ADDENDUM to the
Initial Study and Mitigated Negative Declaration
for the Lake Fordyce Dam Seepage Mitigation
Project

SCH No. 2020090506

Addendum Prepared by HDR

August 2021

Figure 2.1-1. Sediments Along the Cofferdam Alignment

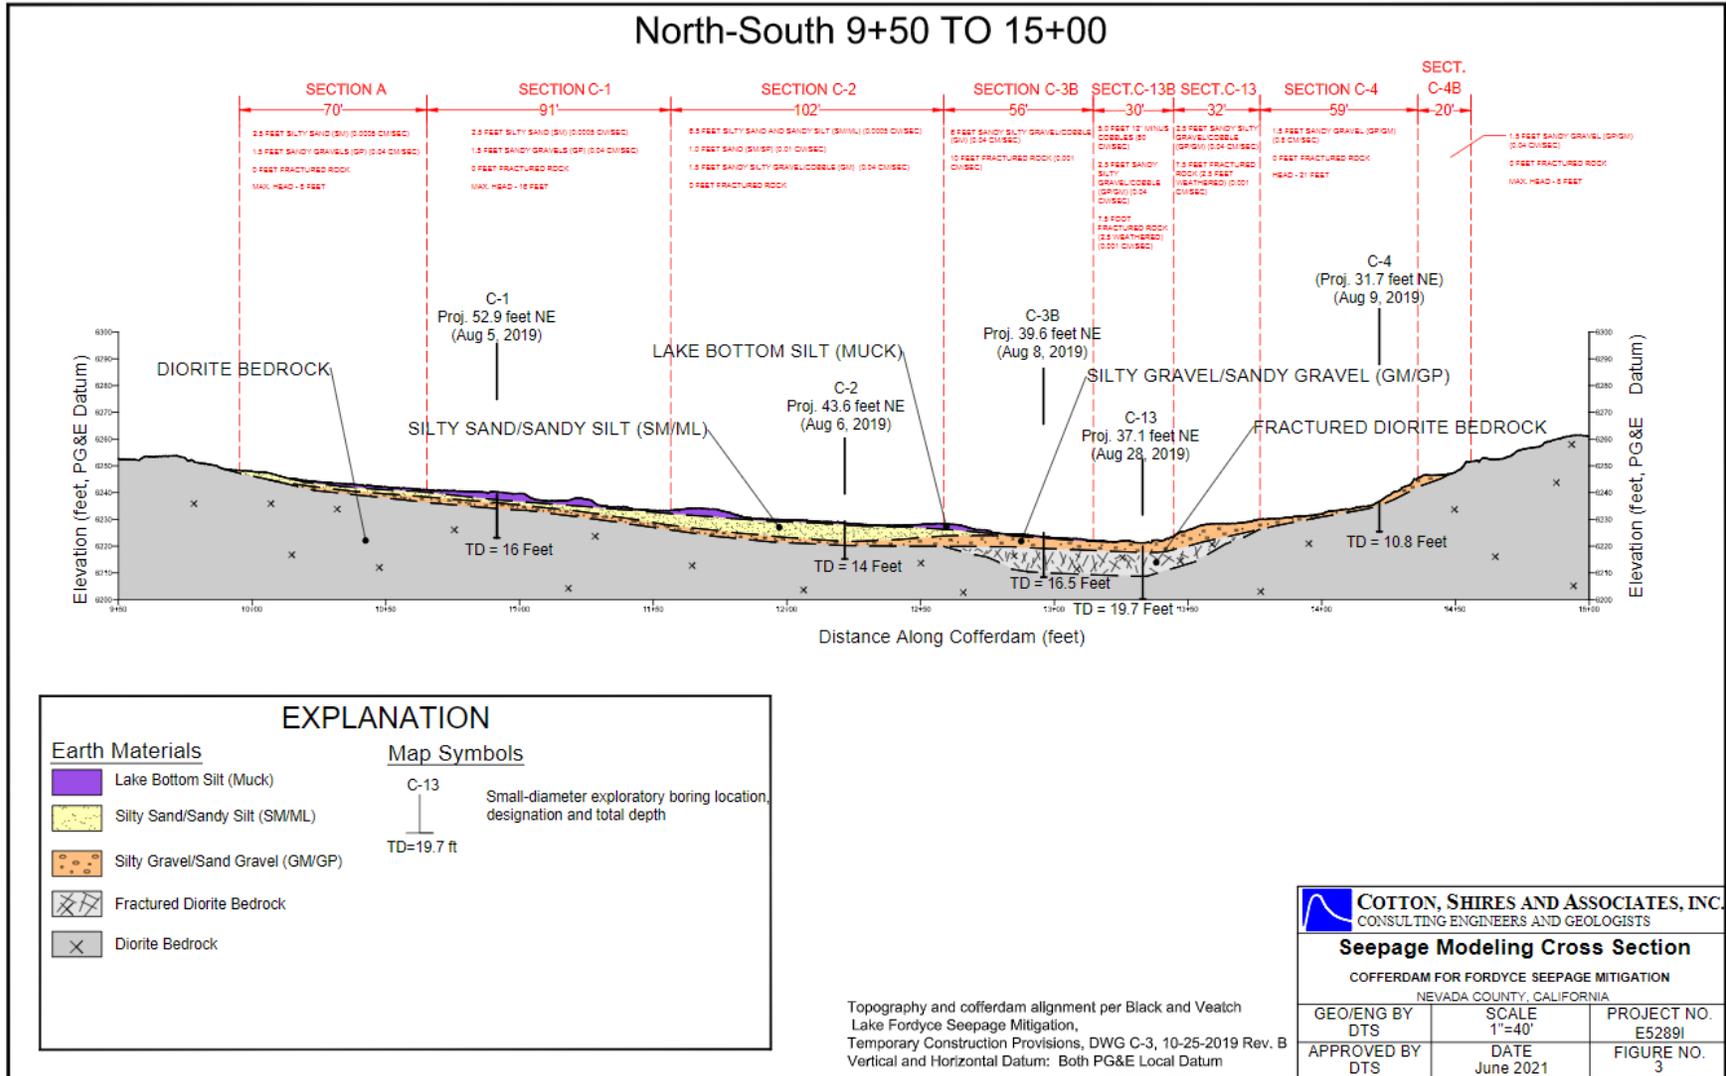
The primary Project modifications relate to dredging (both method and volume), amount of imported material associated with cofferdam construction, disposal of dredged sediments, and Project construction timing. To provide a stable base for the cofferdam, the lake bottom along the cofferdam alignment would be mechanically dredged to stable bedrock, as opposed to the original proposal of suction dredging a smaller amount of surficial silt. A barge-mounted clam-shell excavator would be used to remove approximately 5,000 cubic yards of mud, sand, and gravel from the lakebed beneath the cofferdam alignment. The dredged material would consist of a relatively thin layer of surficial silt (approximately 500 cubic yards), and the remainder would consist primarily of sand and gravel (Figure 2.1-1). The dredged material would be placed on a barge for transport to shore, unloaded into a dump truck using an excavator or loader, and hauled to a designated flat surface area of the staging area downstream of the dam for disposal. The dredged material would be contained in a plastic lined K-rail enclosure to prevent turbid runoff from entering the lake or Fordyce Creek. Every 2,000 cubic yards of sediment disposed of in the staging area downstream of the dam will be tested for mercury, and if determined hazardous will be disposed of in accordance with applicable state and federal requirements.
